Service Bulletin

Bulletin No.: PI0686C

Subject: Front Seat Lateral Movement, Clunk, Squeak, Click Noise or Shift While Cornering

Models: 2012-2015 Buick Regal
2012-2015 Buick Verano
2011-2015 Chevrolet Cruze
2013-2015 Chevrolet Malibu
2014-2015 Chevrolet Impala (VIN 1)
2014 Chevrolet SS

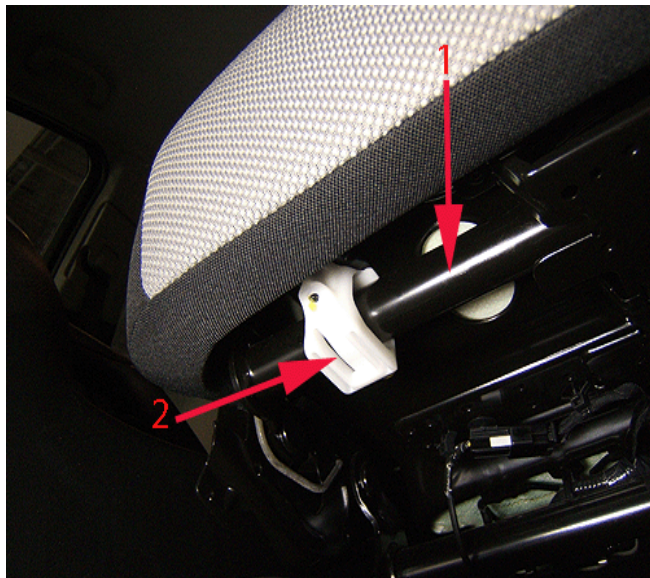
Some customers may comment on a lateral movement in the seat while cornering. This condition has also been described as a clunk, squeak, click noise or shift in the seat. This condition occurs on the driver side 6-way manual or power adjusted seat. This condition may also be present on the passenger side seat if the vehicle is equipped with a 6-way adjustable passenger seat.

This condition may be caused by movement between the seat pan and the seat cross tube.

2773104

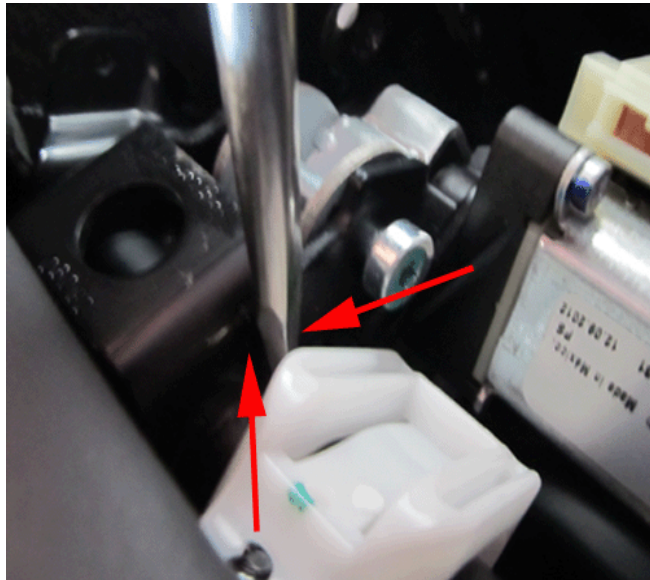
1. Raise the front of the seat bottom to the highest position and move the seat assembly to the rearmost position.

3932441

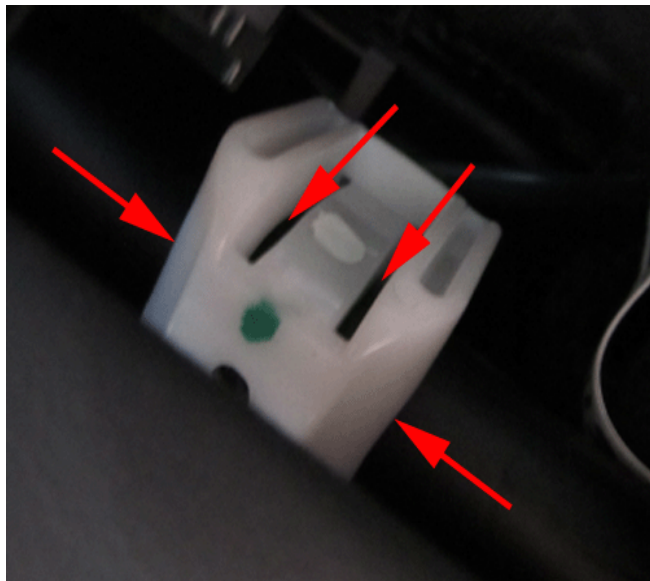
3. Install the clip as shown. Ensure the clip is fully seated around the crossbar and on the guide block.

Note: You may need to move the crossbar using a flat head screwdriver to properly align the clip.

3931436

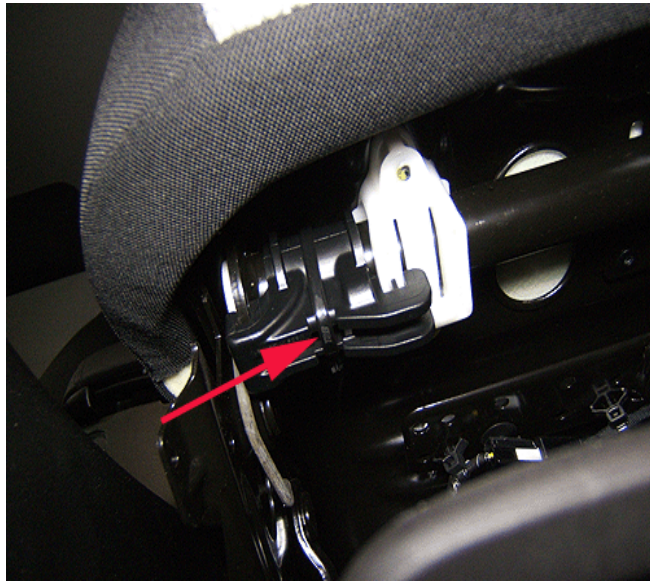
Note: Spray Super Lube, P/N 12346241 (in Canada, P/N 10953474), or equivalent to the areas on the white clip, as shown in the illustration above, to ensure that the noise is eliminated.

2773113

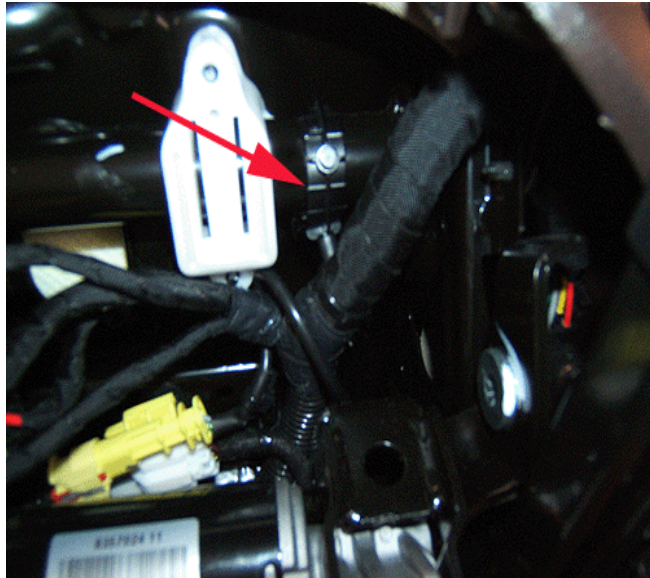
4. Install a nylon wire tie as shown. Trim the excess wire tie material.

2774766

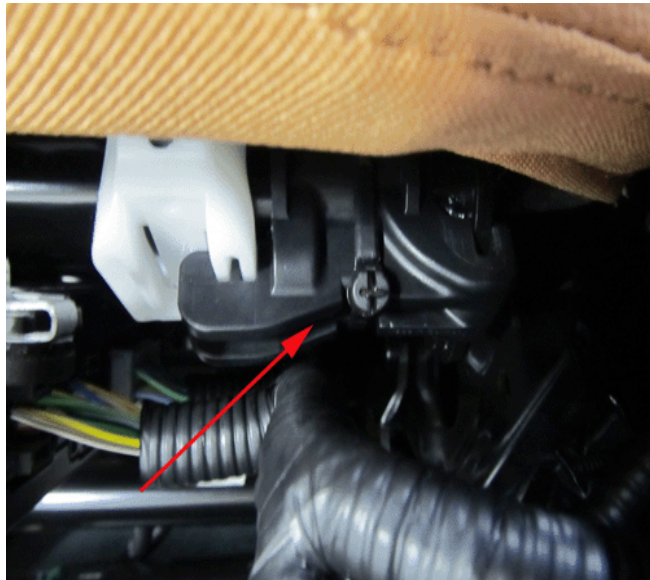
5. On vehicles equipped with power seats, there may be a wire harness attached to the crossbar where the clip is to be installed.
 - If there is a harness clipped to the seat crossbar, remove the harness and clip from the crossbar.
 - Cut the clip off of the harness.
 - Use a second wire tie to re-secure the harness to the new seat clip. Ensure the harness does not come into contact with the connector area of the first wire tie.
 - Ensure that the wire harness is still properly routed after this operation to avoid pinched/cut wires by the power seat mechanism.
